TECHNICAL ORDER
NO. 31R2-4-18-502A

MODIFICATION OF HAMMARLUND COMMUNICATION
RECEIVER MODEL SP-600-JX-17 TO
INCREASE OPERATIONAL EFFICIENCY

DEPARTMENT OF THE AIR FORCE
HEADQUARTERS, UNITED STATES AIR FORCE TECHNICAL ORDER
WASHINGTON 31R2-4-18-502

**MODIFICATION OF HAMMARLUND COMMUNICATION RECEIVER
MODEL SP-600-JX-17 TO INCREASE OPERATIONAL EFFICIENCY**

Figure 1. Location of IF Gain Label and Card Holder

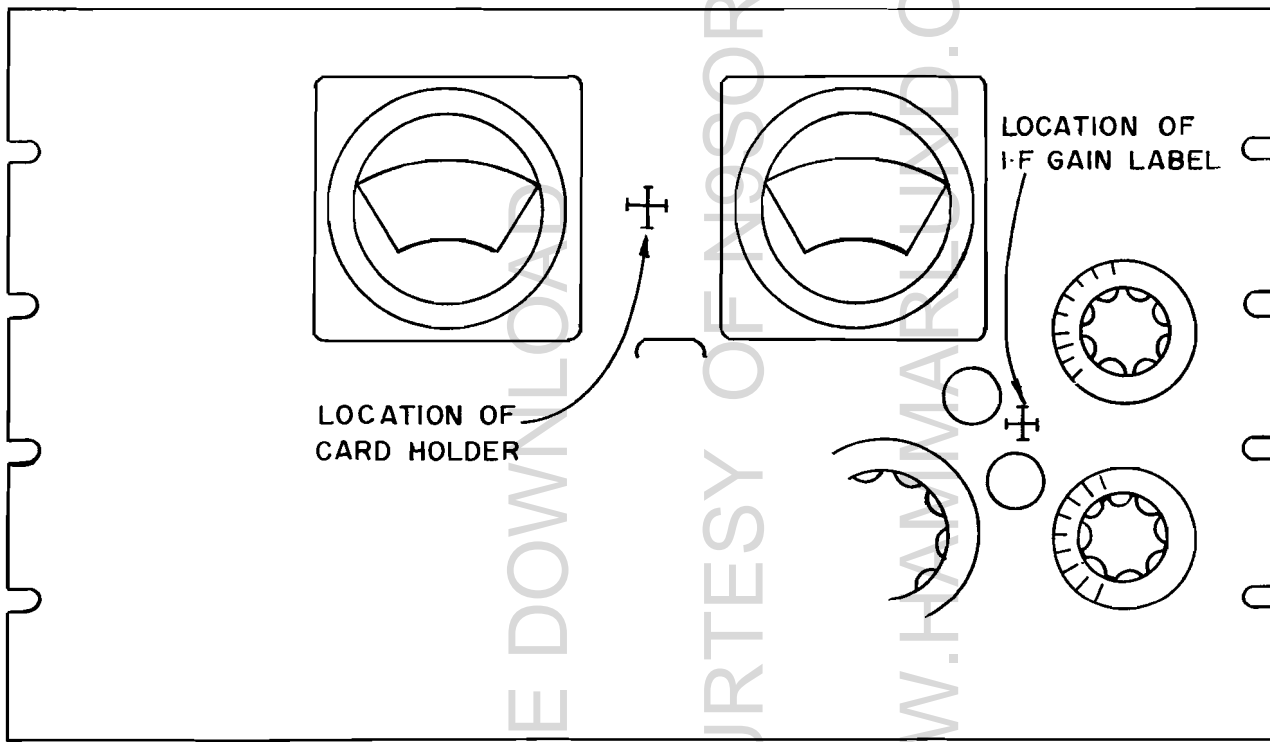
- a. Turn off all power to the receiver.
- b. Addition of IF Gain label and card-holder to the front panel (see Figure 1).
 - (1) Remove bottom plates from receiver and tuning unit.
 - (2) Remove dial lock knob and assembly, retaining the knob, nut and lockwasher for later use with new IF Gain control.

- (3) Place the receiver on its back with the front panel up, in horizontal position.
- (4) Clean the panel surfaces between dial escutcheons and around lettering of dial tuning lock, using an approved cleaning solvent such as trichlorethylene.
- (5) Apply a coating of toluol, supplied in capsule form in the kit, to rear surfaces of IF Gain label and card holder.
- (6) Wait about 30 seconds or until surfaces are tacky, then place the IF Gain label centered over the dial tuning lock lettering, and the card holder centered between the dial escutcheons. Apply even pressure to both labels and allow the adhesive material to harden.

Figure 2. Installation of IF Gain Control

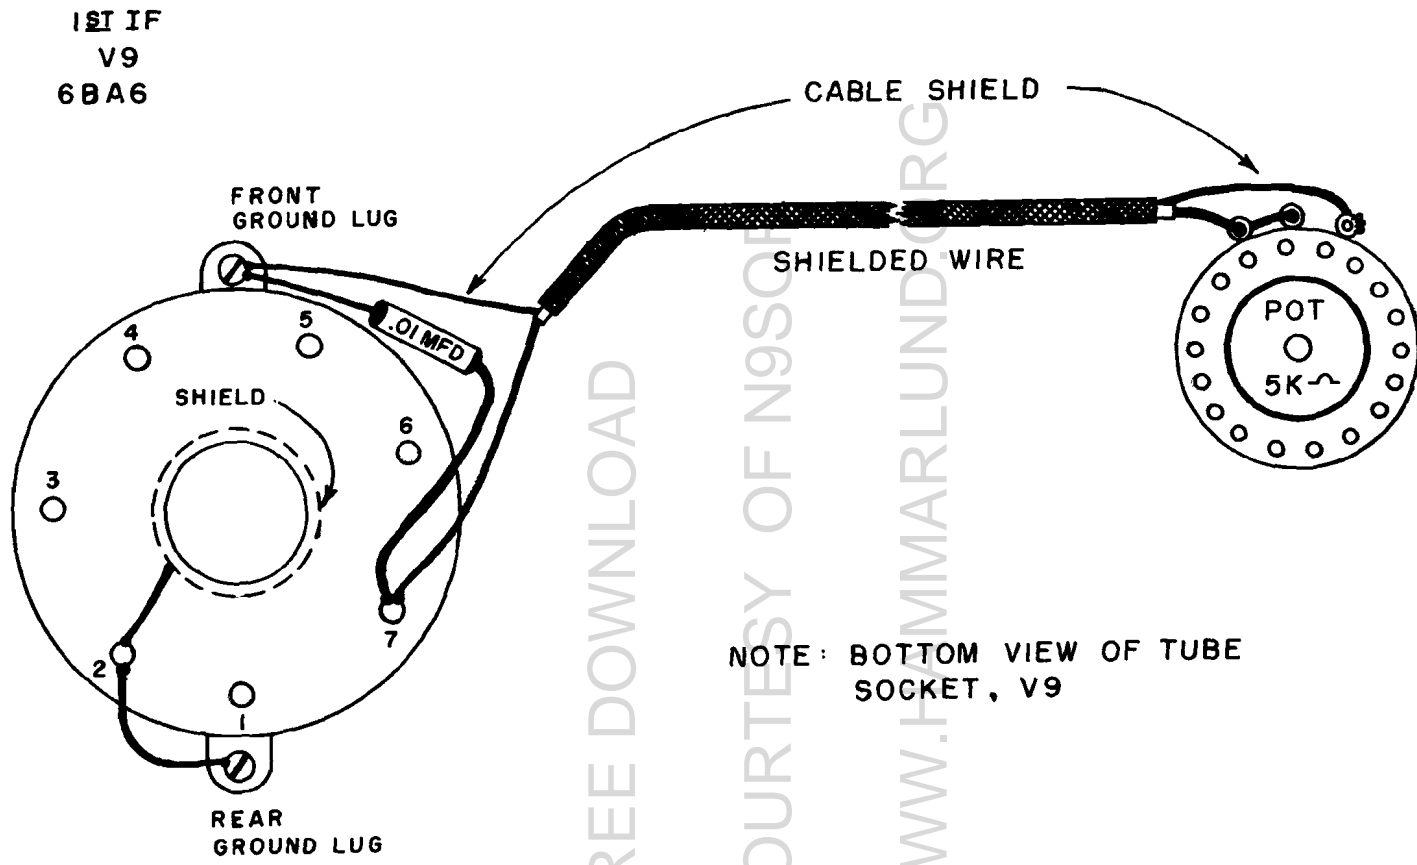
- (10) Connect pin 2 and center shield of socket for tube V9 to the rear ground lug of this socket (see Figure 2).
- (11) Connect the center conductor of new cable together with one lead of new 0.01 mfd capacitor to pin 7 of socket for tube V9 (see Figure 2).

- (12) Connect other lead of the new capacitor and cable shield to the front ground lug of the socket for tube V9 (see Figure 2).

Figure 3. Schematic Diagram of Modification to IF Stage

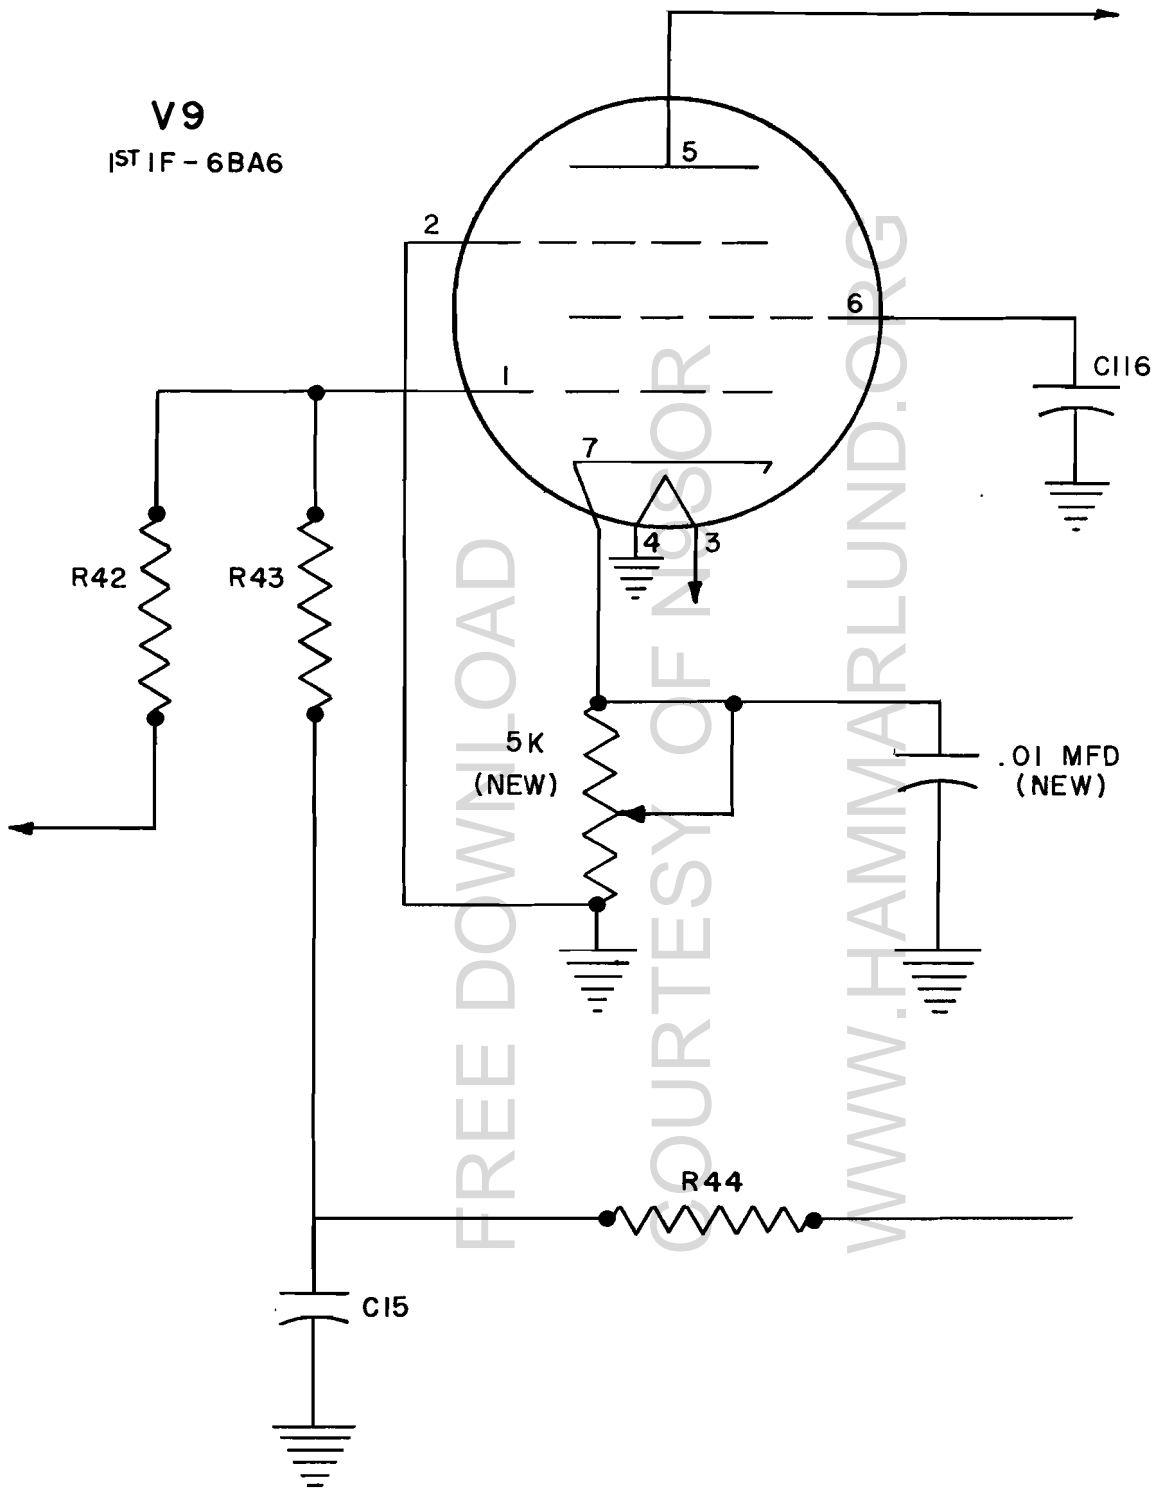
(14) Check the modification against Figure 3.
